Hadley Smart Valve – Raising Suspension

Fig. 1, Hadley SmartValve

Affected Models: 4th Generation Cascadia

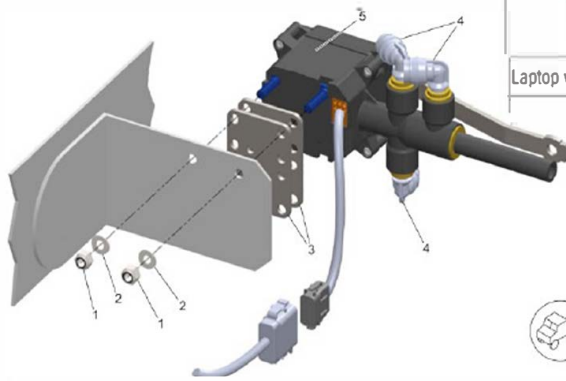
Hadley Valve causing rear suspension ride height to inflate to max

Software bug causing unintended raised suspension while in bobtail mode

Current Field Fix: Replace valve with latest p/n **OR** Laptop + CAN cable firmware to area w/ highest concentration of trucks

Production Changeover Date: December 2025 (any parts received now are the latest version)
